STAFF REPORT KETCHUM PLANNING AND ZONING COMMISSION REGULAR MEETING OF MARCH 9th, 2020

PROJECT: 4th & Main St Mixed-Use Building

FILE NUMBER: P 20-002

APPLICATION TYPE: Pre-Application Design Review

A1.3

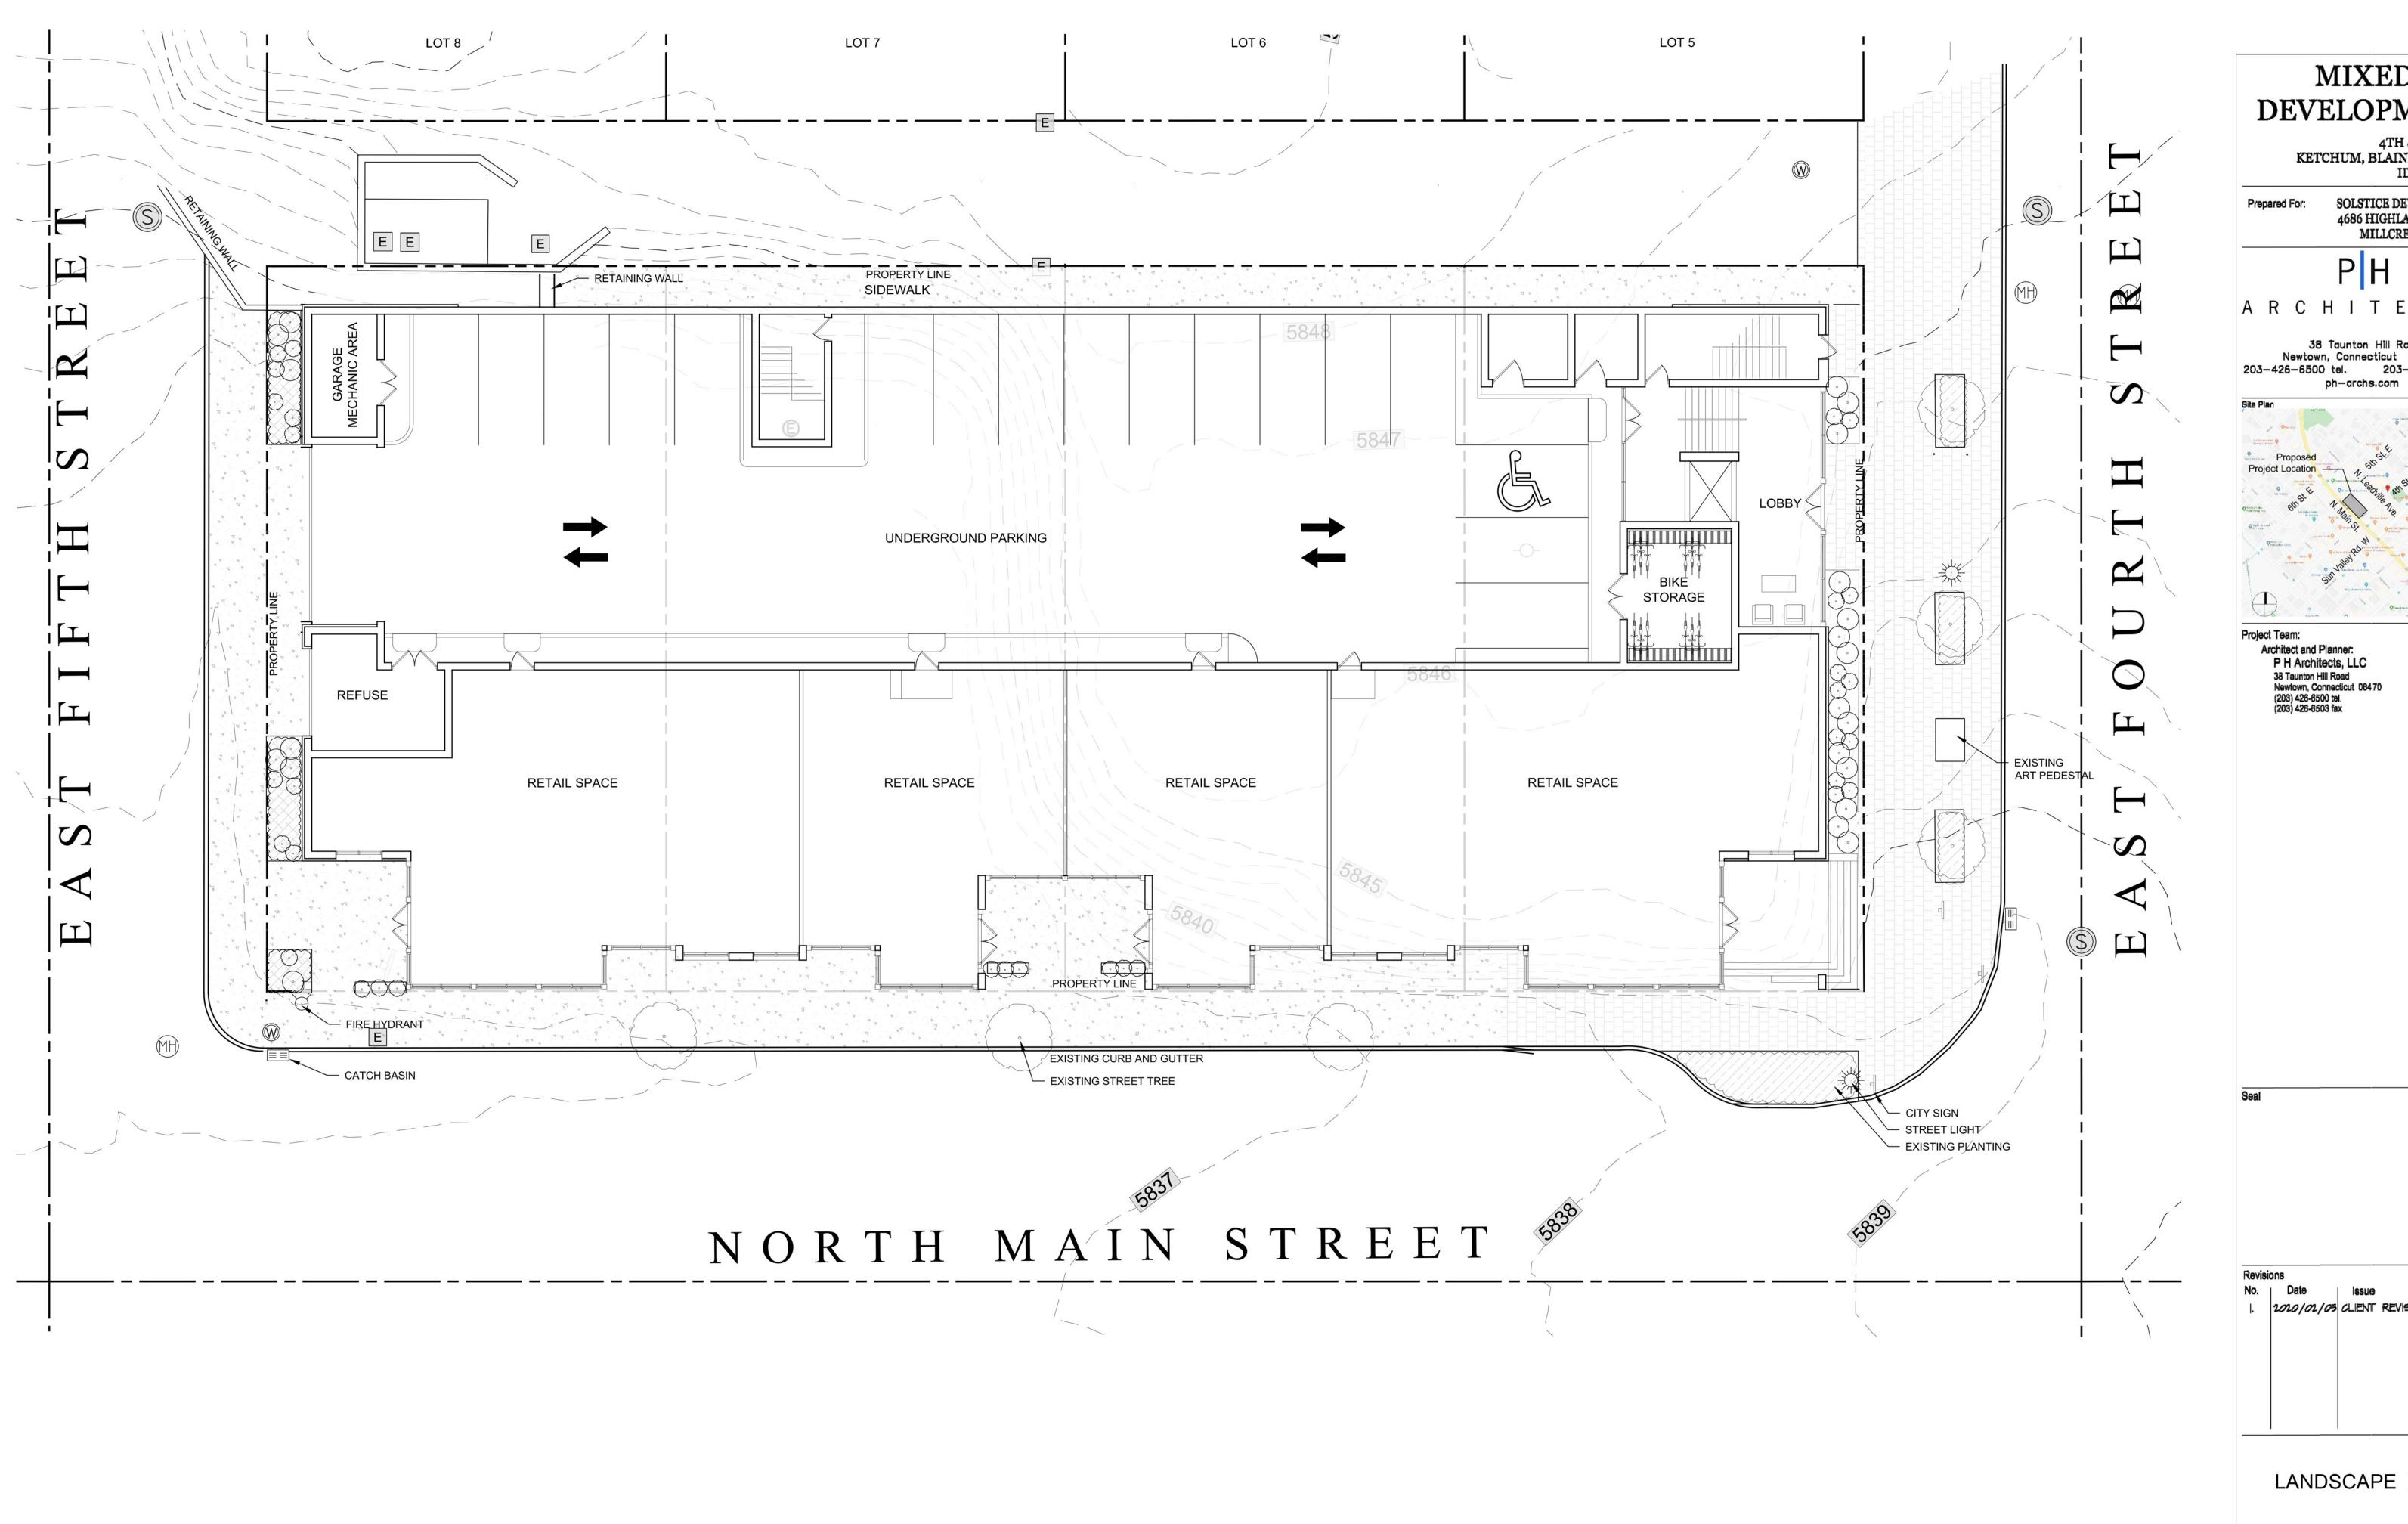
The floor plans on Sheets A1.0, A1.1, A1.2, and A1.3 don't show the location of window or door openings. The elevations indicate residential units with walls comprised entirely of windows. The building's outsides don't match its insides—the exterior of the building doesn't match the residential use proposed within the building. This discrepancy raises a concern that of the preliminary design drawings unrealistically depict the building's appearance.

PERSPECTIVE RENDERING

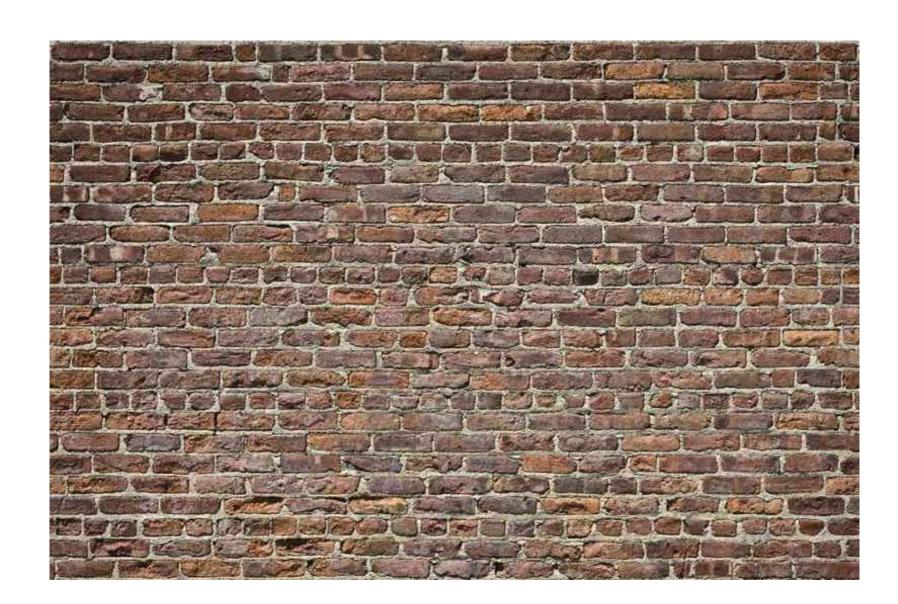
The rendering submitted with the Pre-Application (Sheet A5.0) is an unrealistic bird's-eye view of the building. In order to ensure the proposed development maintains Ketchum's mountain character, the project plans must show the mixed-use building within the context of downtown Ketchum. The final Design Review application must include building renderings within the context of neighboring buildings and from multiple key vantage points throughout town. The renderings should represent realistic points-of-view to show the building's relationship to Main Street and with the existing development in downtown Ketchum.

RENDERED ELEVATION

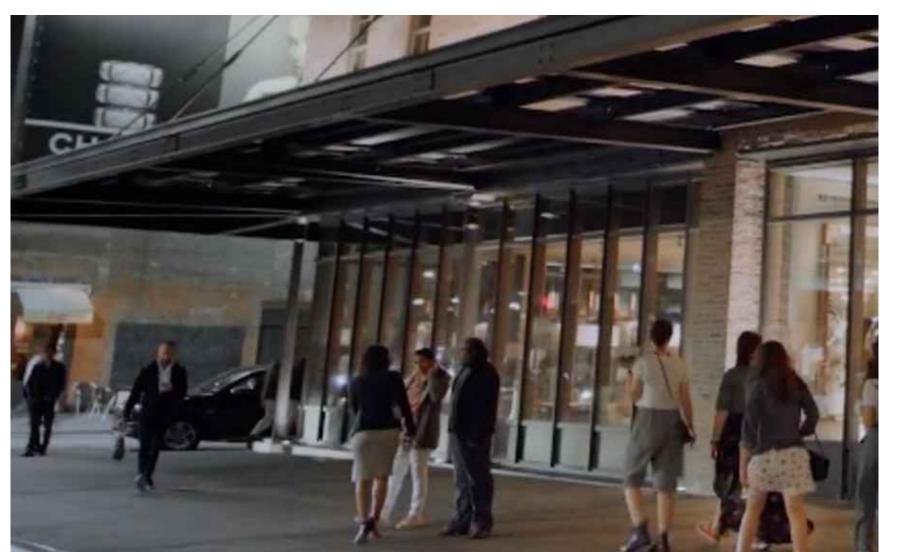
Figure 1: Rendered Elevation, Project Plans: Sheet A5.1

The design is monotonous—three materials, two colors, and rectangular shapes repeat the same pattern. Walls of windows are separated by horizontal bands of red brick and black steel. The building lacks continuity because these horizontal layers fail to provide any connection between floor levels. Horizontal borders of black fascia and red brick separate each floor level. Without any vertical elements to connect floor levels, nothing grounds the building. The building looks like a layered-wedding-cake due to the lack of vertical integration.
